Technical Specification Bases Changes

Technical Justification

MK-B9 Spectrum LOCA LHR Limit Analyses for 177-Fuel Assembly
Lowered Loop Plants

Oconee Nuclear Station
Figure 3.5.2-16a

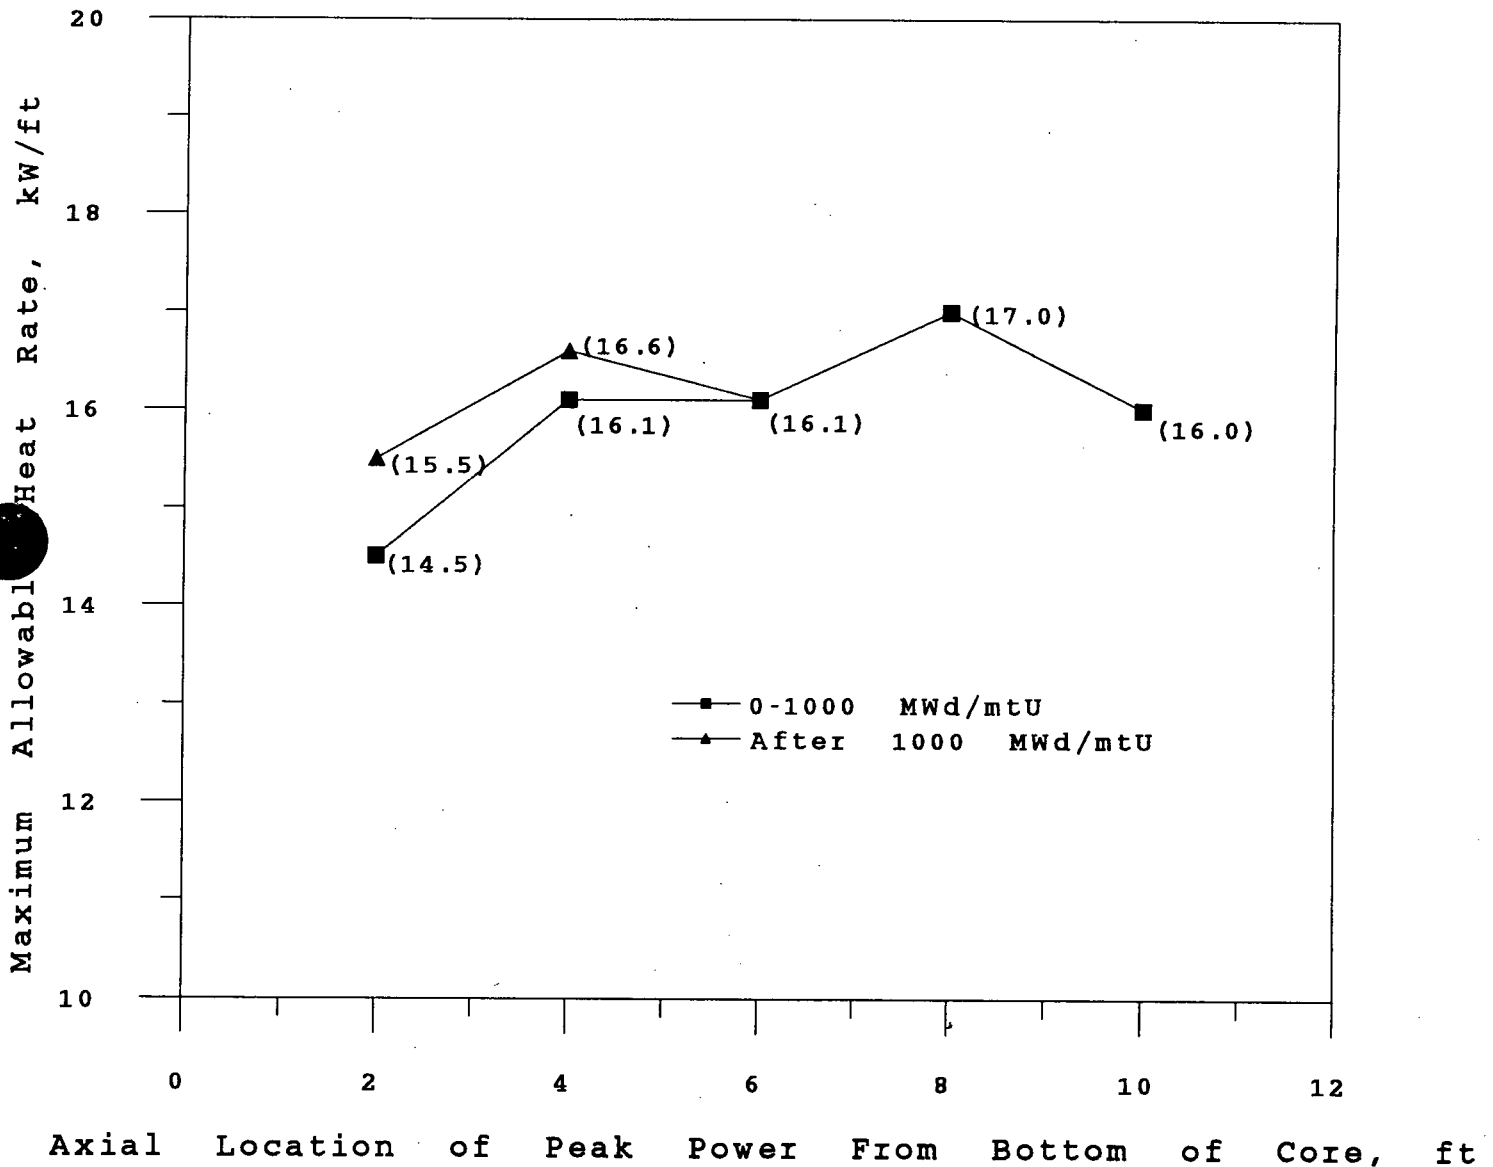
The LOCA linear heat rate limits provided in Figure 3.5.2-16a of the bases of the Oconee Technical Specifications are valid for the Mark B8 fuel assembly design and its predecessors. These limits have been revised to correct problems with the critical heat flux (CHF) correlations in the LOCA Evaluation Model (EM). References 2 and 3 summarize the impact of the CHF correlation problems on the generic LOCA limits for the 177 fuel assembly lowered loop plants. References 4 and 5 docket References 2 and 3 for Oconee Units 1, 2, and 3.

To some extent, Oconee deviates from the generic 177 fuel assembly lowered loop LOCA analyses. As a result, additional analyses were performed for the 4 and 6 foot elevations to

accommodate Ocone specific assumptions. At the 6 foot core elevation the LOCA linear heat rate limit was lowered from 16.5 kW/ft (0-1000 MWd/mtU) and 18.0 kW/ft (after 1000 MWd/mtU) to 16.1 kW/ft for all burnups.

The 4 foot core elevation was reanalyzed using the TACO3 computer code as input to the LOCA EM. Assuming a linear heat rate of 16.1 kW/ft, use of the fuel temperature input from TACO3 resulted in a decrease in the peak cladding temperature from 2160°F to 1786°F. The lower peak cladding temperature associated with the use of TACO3 introduces enough margin to accommodate Ocone specific assumptions without requiring a reduction in the LOCA linear heat rate limit at the 4 foot elevation. The NRC was notified of these results in Reference 5.

The net effect of the EM CHF problems is that the LOCA linear heat rate limit for the 6 foot elevation is reduced to 16.1 kW/ft for all burnups.

Oconee Nuclear Station
 Figure 3.5.2-16b

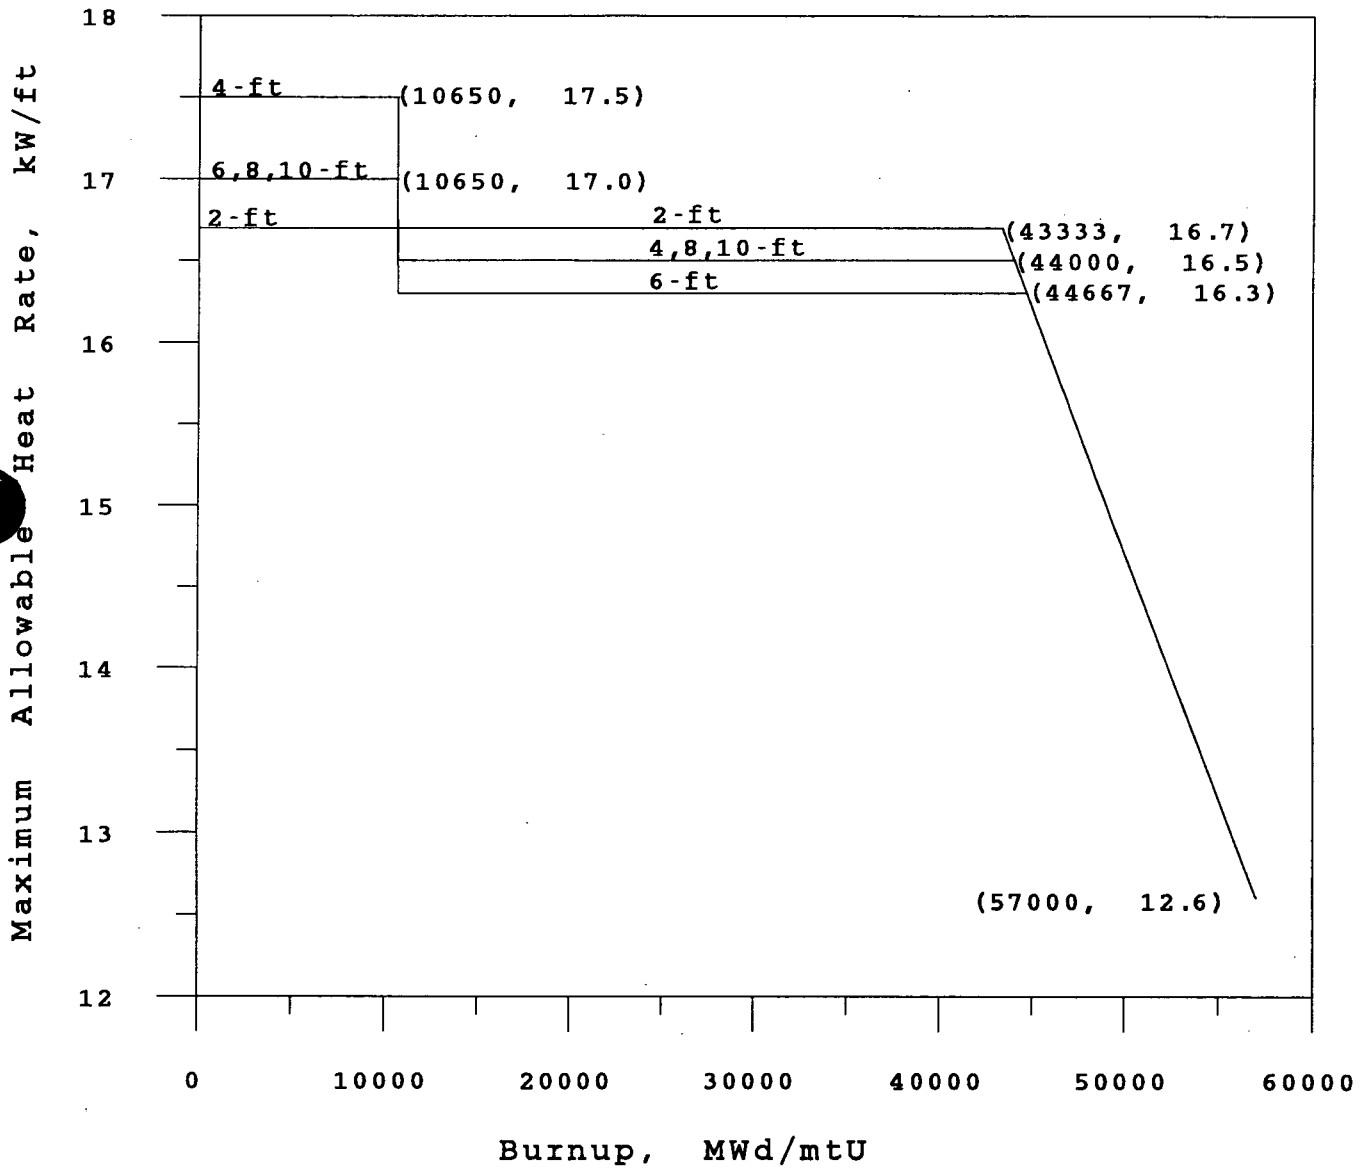
New LOCA linear heat rate limits have been calculated for the Mark B9 fuel assembly design. The beginning of cycle (BOC) LOCA limits have increased because of the lower initial fuel temperature, and hence stored energy, associated with the Mark B9 fuel assembly design. The fuel pellet diameter for the Mark B9 fuel assembly is slightly larger than the diameter for the Mark B8 and previous fuel assembly designs. Since the cladding dimensions remain the same between the Mark B8 and Mark B9 designs, the larger pellet diameter results in a smaller fuel pellet-cladding gap for the Mark B9 design. The smaller gap results in improved BOC heat transfer and a lower average fuel temperature.

In addition to the smaller fuel pellet-cladding gap, the new LOCA linear heat rate limits use initial fuel temperatures predicted by TACO3. As is described in Reference 1, TACO3 is a best estimate fuel performance code which predicts lower fuel temperatures than the TACO2 code. In the past, the TACO2 code has been used to determine the initial fuel temperatures for the LOCA analyses. Thus, the combined effect of the smaller gap size and TACO3 is that, for a given linear heat rate, the initial fuel temperature is significantly lower for the Mark B9 LOCA analyses than with the Mark B8 LOCA analyses.

Reference 1 is a report summarizing the LOCA linear heat rate analyses for the Mark B9 fuel assembly (attached). As was described earlier, the Mark B9 average fuel temperature is lower than the average fuel temperature for a Mark B8 fuel assembly because of a smaller diametral gap. Thus, for a given linear heat rate, the stored energy in a Mark B9 fuel rod is less than in a Mark B8 fuel rod. In addition, the TACO3 fuel performance code was used to specify average fuel temperature input for the LOCA EM. As is described in Reference 1, this fuel performance code predicts lower BOC fuel temperatures than the previously used fuel performance code, TACO2. The net effect of these changes is that the average fuel temperature is significantly lower in the Mark B9 fuel assembly than in the Mark B8 fuel assembly.

The lower BOC average fuel temperature associated with the Mark B9 fuel assembly introduces margin into the BOC LOCA linear heat rate limits. This margin is partially offset by changes in other EM input assumptions. In the past, the generic LOCA analyses have assumed nominal values for some of the ECCS input assumptions. For example, the nominal Technical Specification value of 600 psig was assumed for the core flood tank cover pressure. In an attempt to account for plant specific variations in some of these inputs, the B&W Owners Group (B&WOG) utilities developed a new set of bounding, generic assumptions for the 177 fuel assembly lowered loop plants. These new generic assumptions are described in Reference 1 and are used in the Mark B9 LOCA analyses. These assumptions tend to partially offset the gains associated with the lower fuel temperature of the Mark B9 fuel assembly. A detailed description of the analyses supporting the Mark B9 LOCA linear heat rate limits is provided in Reference 1 (attached).

Because of the above described differences in the fuel assembly design, Duke Power Company will use the LOCA limits in Technical Specification Bases Figure 3.5.2-16a for the Mark B8 fuel assembly design and its predecessors. The LOCA limits in Technical Specification Bases Figure 3.5.2-16b will be applied to the Mark B9 and subsequent fuel assembly designs. Operation of the fuel assemblies within their respective LOCA linear heat rate limits ensures compliance with the acceptance criteria of 10 CFR 50.46.
